File Number: D07-12-21-0180

**Re: Site Plan Control Application**

**91 Holland Avenue**

The following comments are provided in response to the first submission of the above application. Please review the items below, revise plans accordingly and provide a cover letter indicating how each of the comments has been addressed through the resubmission. ~~Please provide 3 sets of all revised plans as well as PDF copies of these plans.~~

### *Landscape Plan*

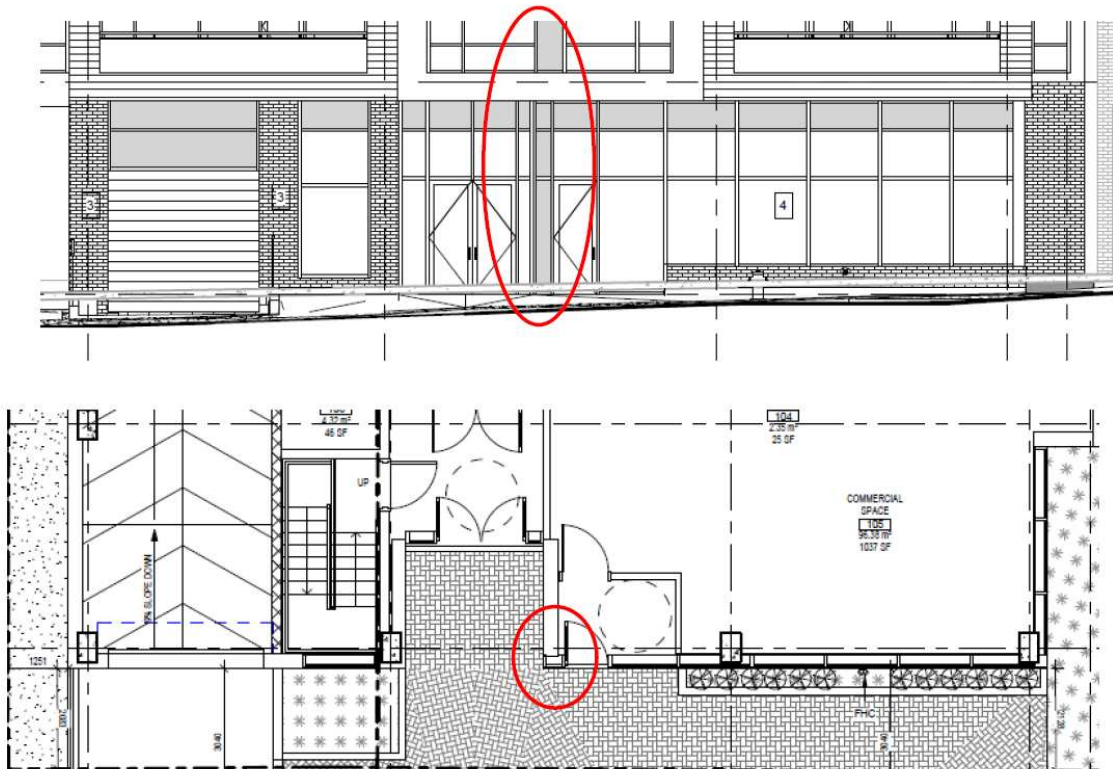
6. Please find ways to include more softscaping in the front yard. Perhaps a low planting bed next to the garage entrance. Please provide landscape plan with this.

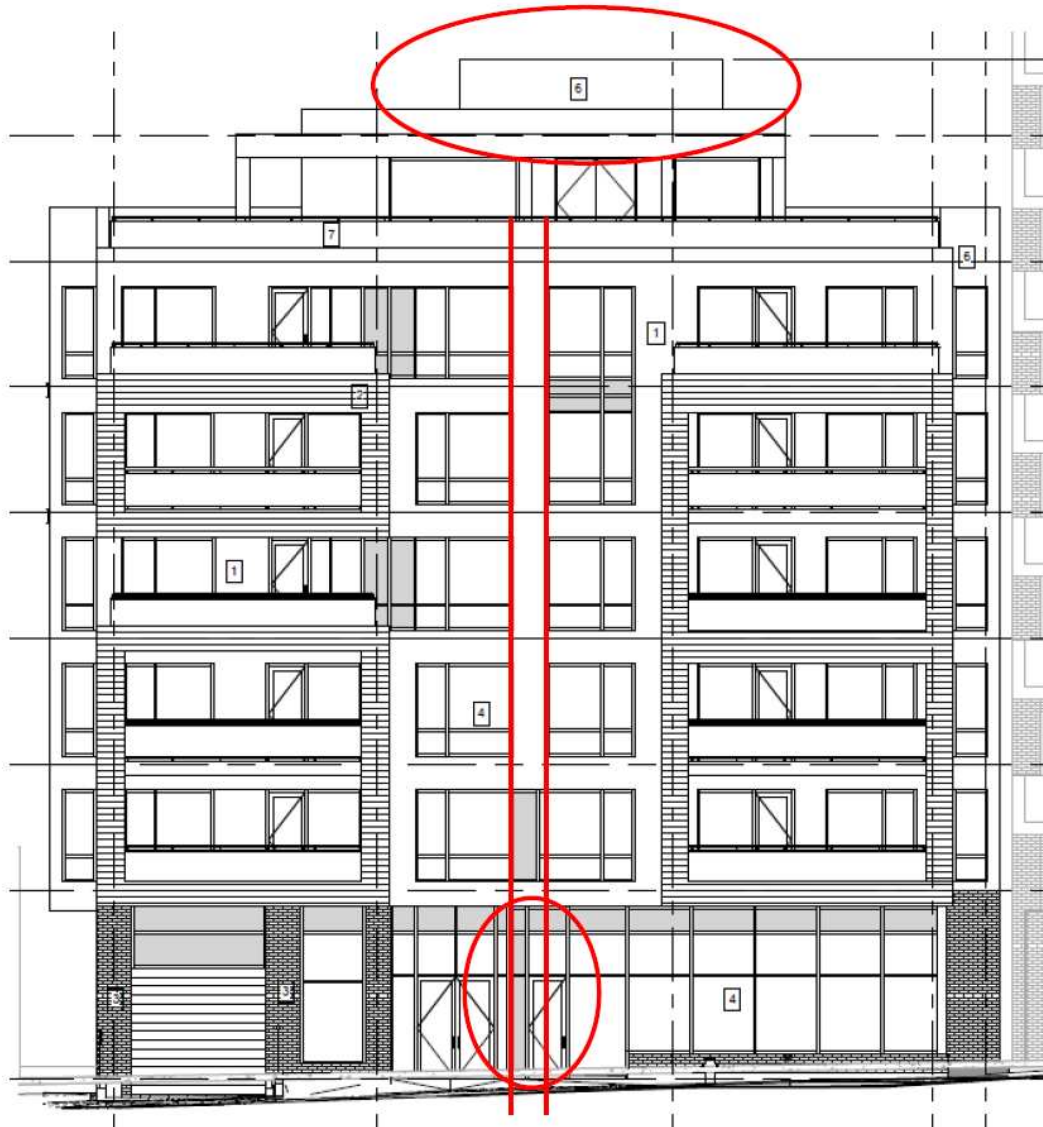
5. The narrow planters in front of the ground floor commercial space is not most conducive to retail/commercial uses.
6. Please study the area between the residential entrance and the commercial entrance in terms of façade treatment and materiality. For example, if a brick wall is to be installed between the residential entrance and the commercial unit, perhaps the wall should have a slightly wider return on the façade to create an alignment with the walls on the upper floors. If the idea is to present the commercial unit as a “glass box”, perhaps the brick wall between the residential entrance and the commercial entrance should be removed and replaced by a glass (see attached diagrams).
